On Rey County County Rolling Agency Response and Revised Site Investigation Report Re:

Shell-branded Service Station 9750 Golf Links Road Oakland, California SAP Code 135683 Incident #98995744

Fuel Leak Case # RO0002441

Site Vicinity/ Area Well Survey Map

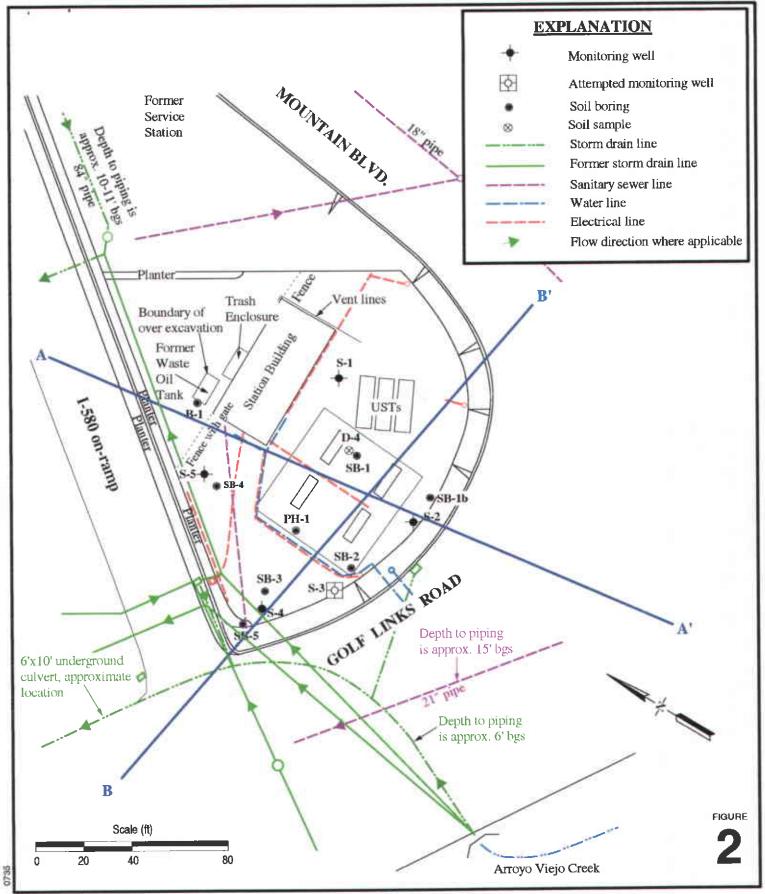
2000 Sensitive Receptor Survey: In 2000, Cambria conducted a sensitive receptor survey for a ½-mile radius of the site. Results of the survey are shown on Figure 1. The only well identified within the ¼-mile survey radius was a cathodic protection well located approximately 1,150 feet north-northwest of the site. Arroyo Viejo Creek was the only identified surface water body within the survey radius. The Arroyo Viejo Creek is located both above-ground and below ground in culverts in this area. From south-southeast of the site, the Arroyo Viejo is aboveground and flowing to the west. It flows underground at a culvert inlet approximately 60 feet south-southwest of the site, and flows beneath Golf Links Road. Ultimately, the Arroyo Viejo Creek daylights again over 500 feet to the northwest, near Encina Avenue and Golf Links Road (Figure 3).

Geologic Cross Section A-A'

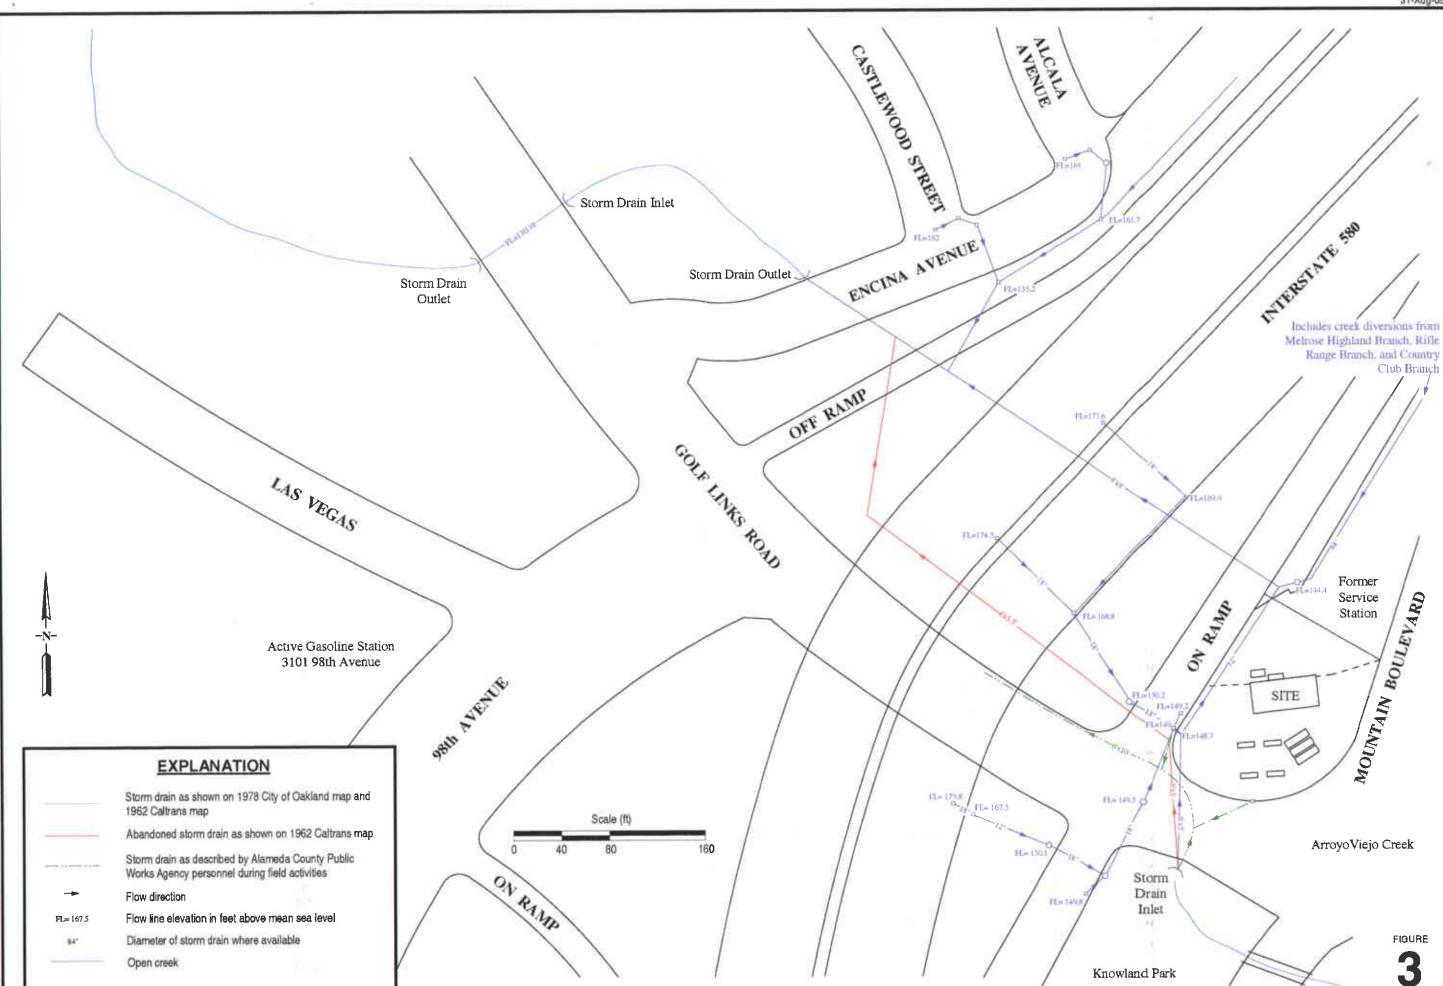
Technical Comment #4. Cross Sections. The revised report is to include one north-south and one east-west cross section.

Agency Response #4. Cross-sectional diagrams are included as Figures 4 and 5. The cross-sections show surface topography, locations of site features and underground utilities in the site vicinity, lithologic interpretation, screen intervals for each monitoring well, analytical results from soil samples, grab groundwater data from historical borings, and groundwater elevation and constituent concentrations from the June 2005 monitoring event.
